APPLICATION NO.	FILING DATE	FIRST NAMED INVENTOR	ATTORNEY DOCKET NO.	CONFIRMATION NO.
10/563,894	06/01/2006	Katri Keski-Nisula	PLA078-820714	7027

Office Action Summary	Application No. 10/563,894	Applicant(s) KESKI-NISULA ET AL.	
	Examiner YOGESH P. PATEL	Art Unit 4111

DETAILED ACTION

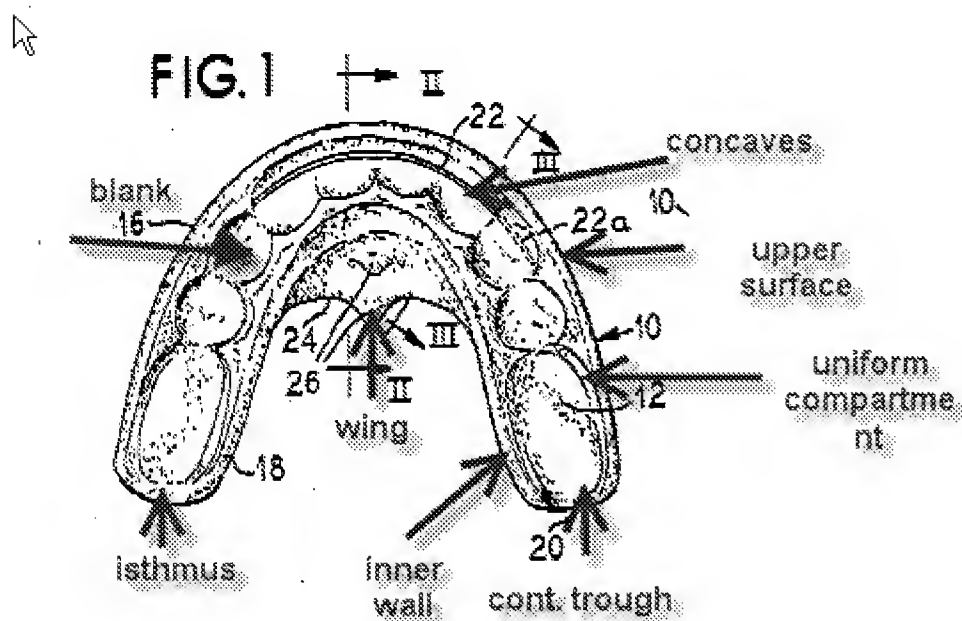
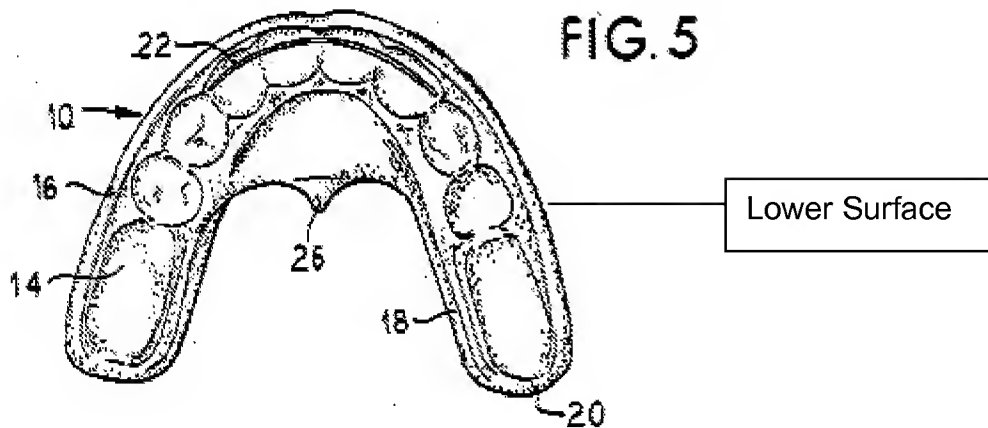
17. Claims 1-6 are rejected under 35 U.S.C. 102(b) as being anticipated by Bergersen (Pat. 4,784,605).

Regarding claim 1 Bergersen discloses an orthodontic device for guiding the occlusion of an individual, the device including a generally U-shaped arch made of flexible material (col. 3, lines 13-16) and that has a lower surface on the lower jaw side and an upper surface on the upper jaw side, and in both of which there are concaves for receiving the individual's teeth (col. 2, lines 35-40), the bottoms of the concaves forming an isthmus which separates the concaves from one another, wherein the isthmus includes blanks intended for individual teeth and uniform, continuous recesses (e.g. trough) for at least two teeth to guide the teeth in the required direction, and the lower jaw side surface has a lower wing constricting the tongue at least sideways, and it has been shaped to further placement of the device in the individual's mouth (see the provided figure). Regarding claim 2 Bergersen discloses the recesses (e.g. trough) contain uniform compartments that begin from the second premolar and continue towards the molars at least partly to the area where the second permanent molar will erupt (see the provided figure). Regarding claim 3 Bergersen discloses the side walls of the uniform compartments are formed by outer and inner walls, respectively, which have essentially straight walls (see the provided figure). Regarding claim 4 Bergersen discloses the compartments are shaped like continuous troughs, and the troughs are open from the molar side end (see the provided figure). Regarding claim 5 Bergersen discloses the recesses contain uniform recesses (compartment) limited to the area of

the front teeth, and the surface walls of the recesses are essentially smooth. Regarding claim 6 Bergersen discloses the concaves have their own blanks for canine teeth and the first premolars (see the figure).

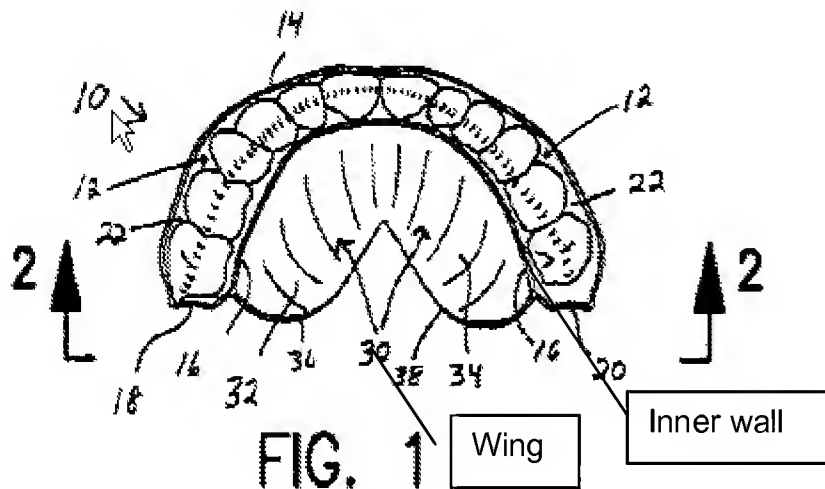
19. Claim 7-9 and 18-23 are rejected under 35 U.S.C. 103(a) as being unpatentable over Bergersen'605 as applied to claim 1 above, and further in view of Bergersen (Pat. 5,645,420).

Regarding claim 7-9, Bergersen'605 discloses all elements of the claimed invention except for a thickness of the isthmus.

Bergersen '420 teaches the variation of the isthmus thickness for the correction of the overbite can be accomplished either by reducing the thickness in the area of the posterior teeth or increasing the thickness in the area of the anterior teeth (col. 6-7). Similarly, by increasing the thickness of the isthmus in the posterior region relative to the anterior region, an open bite can be corrected. The variation in thickness of the isthmus occurs in step because the thickness is different in anterior and posterior portions. It would have been obvious to a person of ordinary skill in the art at the time of the invention was made to have provided a varying thickness of the isthmus of the device as taught by Bergersen'420 to the orthodontic device of Bergersen to correct open bite/overbite problems (col. 6, lines 49-67 and col. 7, lines 19-42).
